Technical Note

Project No: ITL16195
Project Title: Broadwater Gardens
Title: HCC Highways Response
Ref: NM/MD/ITL16195-007
Date: 19 February 2021

STATUS: FOR INFORMATION				DATE: 26.01.21				DRAWING No: ITL16195-GA-011		REV: A

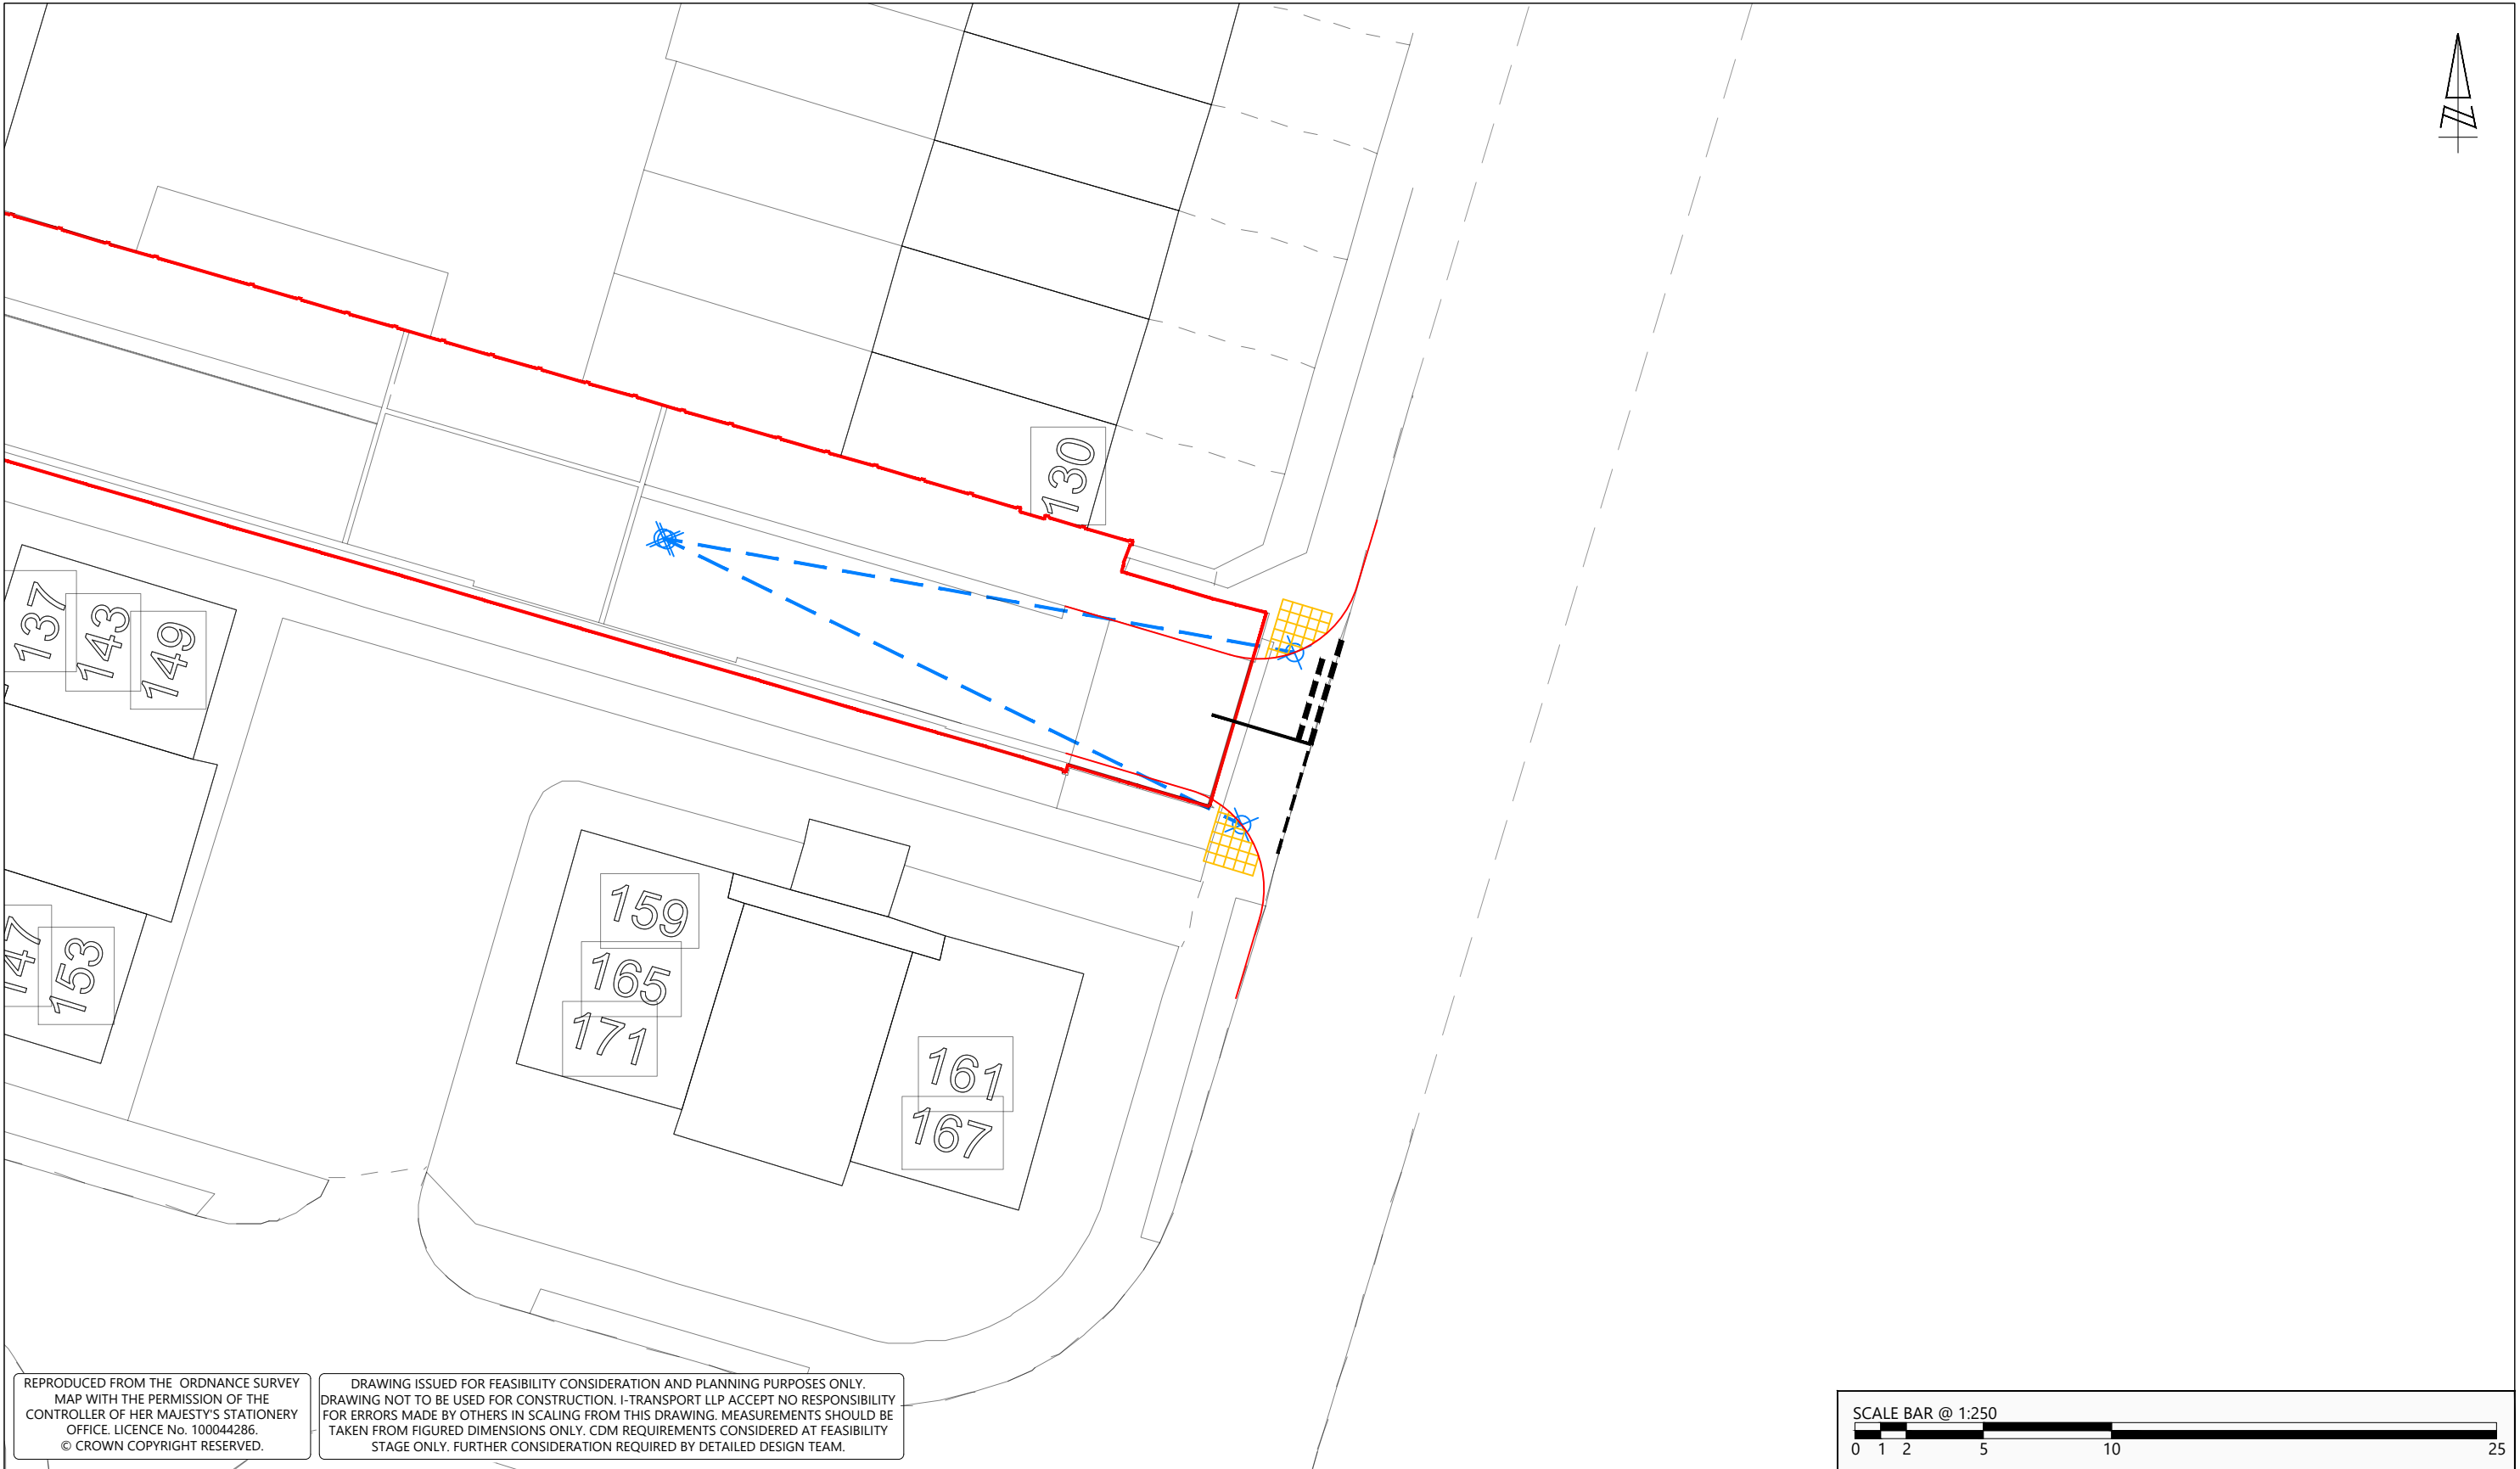
“refuse vehicle tracking shows incursion into the opposing carriageway when starting the left turn manoeuvre [from Broadwater Road] which could cause conflict with vehicles travelling in the opposing direction leading to possible head on collisions or side swipe collisions”

1.5.2 Notwithstanding these points, as set out above, the carriageway at the access has been widened and thus the updated swept path analysis of a refuse vehicle is provided in Drawing No. ITL16195-GA-010A. In addition, the swept path analysis if the most frequent vehicle movement likely to occur (a car passing another car) at the site access has also been updated and is illustrated in Drawing No. ITL16195-GA-011A.
